# Marketside Flats Skybridge

## Meeting Summary

**January 3, 2019**

Merit & Public Benefit

Figure 2: Proposed intersection improvements

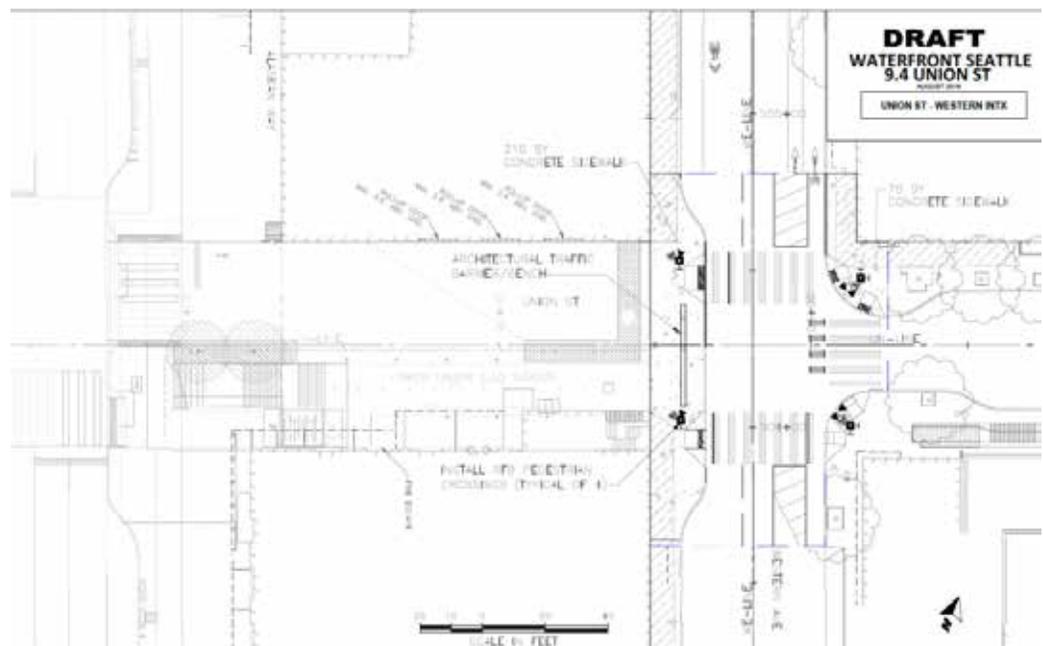
The Commission discussed the proposed public benefit package. While the Commission is comfortable with accepting design updates to Union St and Western Ave intersection as part of the proposed public benefit package, Commissioners acknowledged the early stages of the proposed design and is prone to changes in the future. The Commission then stated that they wanted more detail regarding the design of the proposed barrier along the western edge of Western Ave. The commission encouraged the project team to coordinate with the Office of the Waterfront to design the proposed barrier similarly to the design of planters and pedestrian seating used elsewhere along the waterfront. Commissioners also encouraged the project team design the barrier in a way to make it appear like pedestrian scaled street furniture while functioning as a barrier for vehicles. The SDC agreed the project team should return for a subcommittee review of detailed design of the proposed barrier as well as potential changes for the overall design of the intersection.

The SDC acknowledged that there are no conflicts between the skybridge and existing or proposed utilities. Commissioners then discussed potential conflicts elements form the proposed public benefit package might have with existing or proposed utilities.

1. Prior to Council approval of the ordinance to re-authorize this skybridge, the applicant will return for a subcommittee review to review the details of the proposed barrier, changes to the intersection design, and content and design of the proposed plaque.
